729182 PDM Harness Tech Bulletin

Description of problem: Lift Manifold connectors on the 729182 PDM Harness do not have enough flexibility after the branch to allow for easy installation of the connectors to the pressure sensor and lift valve solenoid.

Affected Harnesses: Any 729182 harness that was shipped between Oct 15, 2019 and Feb. 7, 2020 could be affected (see notes on identifying affected harnesses below). This includes harnesses shipped as part of the 729180 Power Distribution Module or the 729210 SRM Base Kit.

Problematic Harness:

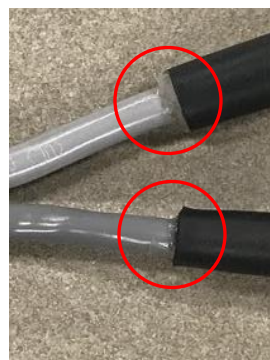
The problematic harnesses have **ALL** of the following:

- Single yellow strand in the braided looming of the harness
- Heat shrink at the back of the connector with adhesive visible at the end of the heat shrink.

Yellow strand in braided looming with heat shrink installed at back of connector.

Adhesive visible under heat shrink

Precision Planting will be sending **729699 Solenoid Extension** to any dealer that was shipped the 729182, 729180, or 729210 between the affected dates. 729699 is a 12" extension for the 2 pin connector that connects to the Lift Valve Solenoid. This will allow more length between the 2 connectors and alleviates any strain on the connectors.

Good Harnesses:

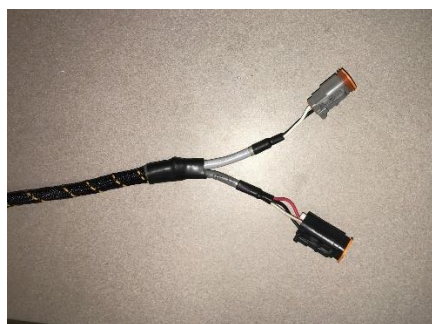
No yellow strand in braided looming, heat shrink is present but with no adhesive, making it pliable.

Yellow strand is present in braided looming but no heat shrink on connectors.
